Access Compliance Report

Public Rights-of-Way

(Curb Ramps)

Intersection ID: 23300	Main Street: SHARON_RD_WEST	Cross Street: SHARONBROOK_DR	Location: NE
ADA ID: 89FAD0F852BF	Ramp Type: PerpDiag	Initial Pass/Fail: Fail	Overall Compliance: No
Codes/Mitigation Info/Possible Solution		Field Measurements/Component Compliance

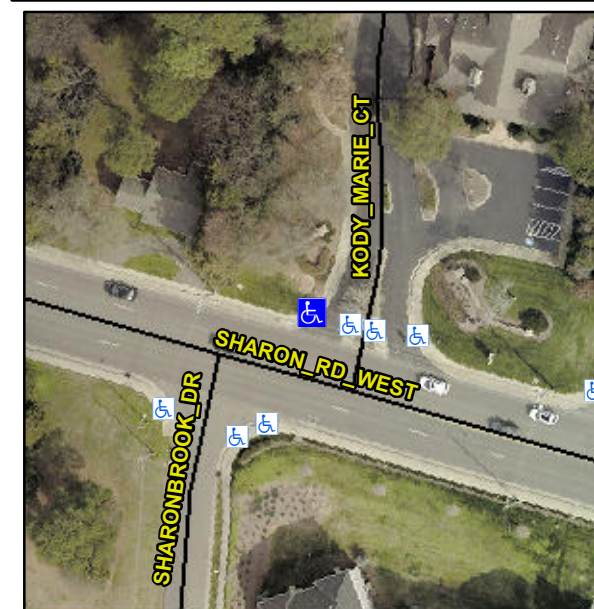
Possible Solutions:

Remove & Replace Curb Ramp With Two New Directional Ramps or Equivalent.

PROW/ADA:

R304.2.2, R304.5.3
